ENGINE - HP COMPRESSOR - FRONT SHAFT AND SEAL ASSY WITH STIFFENED SEAL CARRIER -
CATEGORY CODE 7 - MOD.ENG-72-0026

V2500-ENG-72-0026

SERVICE BULLETIN

Location of H.P. compressor front shaft and seal assembly
Fig.1

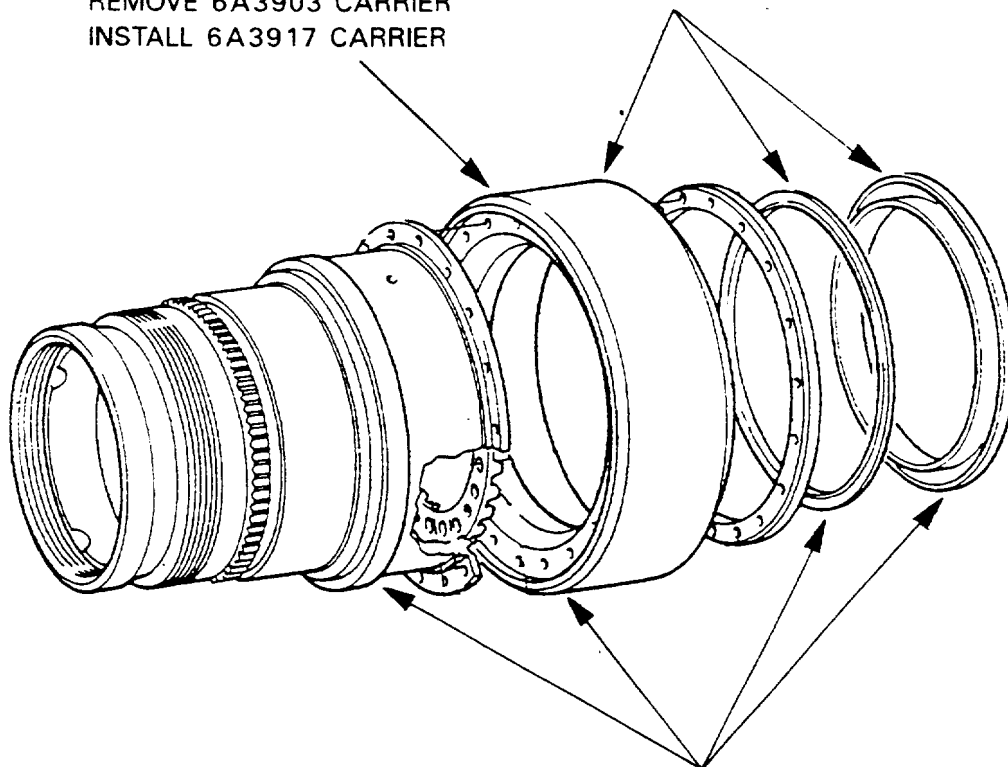
- (a) A new HPC front shaft and seal assembly is introduced which features a shorter seal diameter, thicker outer front diameter and increased flange thickness.

REMOVE 6A3903 CARRIER
INSTALL 6A3917 CARRIER

REMOVE 6A3902 CARRIER ASSEMBLY
INSTALL 6A3916 CARRIER ASSEMBLY

REMOVE 6A3898 SHAFT AND SEAL ASSEMBLY
INSTALL 6A3915 SHAFT AND SEAL ASSEMBLY
